CITY of NOVI CITY COUNCIL

Agenda Item 2
September 16, 2013

SUBJECT: Consideration of the request of Ivanhoe Companies for JSP 13-47 with Zoning Map Amendment 18.704 to rezone property in Section 18, on the west side of Wixom Road south of Grand River Avenue from B-2, Community Business and I-2, General Industrial to RM-1, Low Density Low-Rise Multiple-Family Residential with a Planned Rezoning Overlay. The property totals 29.20 acres and the applicant is proposing an 86 unit single-family residential development.

PLAN REVIEW CENTER REPORT

ELEVATION A

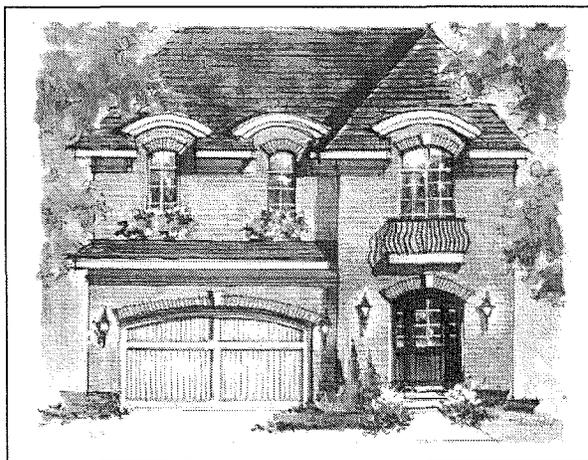
Similar / Dissimilar Ordinance, Section 303 - The Similar / Dissimilar Ordinance requires a variation in appearance in the front elevations of adjacent homes (Sec. 303.2), and requires that homes within the larger development be consistent in design quality based on certain criteria; size (square footage), types of material, and overall architectural design character (Sec. 303.1).

With respect to Section 303.2, all nearby homes (two on the left, two on the right and any across the street that overlap by 50%) must not be “substantially similar” in appearance to the proposed home. Specific criteria for compliance can be found in the Ordinance. The applicant has provided four renderings, all of which appear to be derived from the same or similar floor plans. End-to-end reversal is not considered a dissimilarity. Therefore elevations C & D would be considered “substantially similar” under this section. Only 3 of the elevations provided would be considered dissimilar. It is our experience that compliance with the Similar / Dissimilar Ordinance typically requires a minimum of 5 dissimilar facades or models within a given development. Considering the specific layout of this site plan, as many as 10 elevations may be included in the comparison for a given units (for example unit 82). For this reason and to account for uneven sales popularity and to allow greater flexibility, a greater number of elevations would be desirable. We believe that compliance with the Similar / Dissimilar Ordinance could not be achieved given the quantity of models provided. *It is recommended that the applicant provide additional façade examples to more adequately demonstrate how compliance with Section 303.2 will be achieved.*
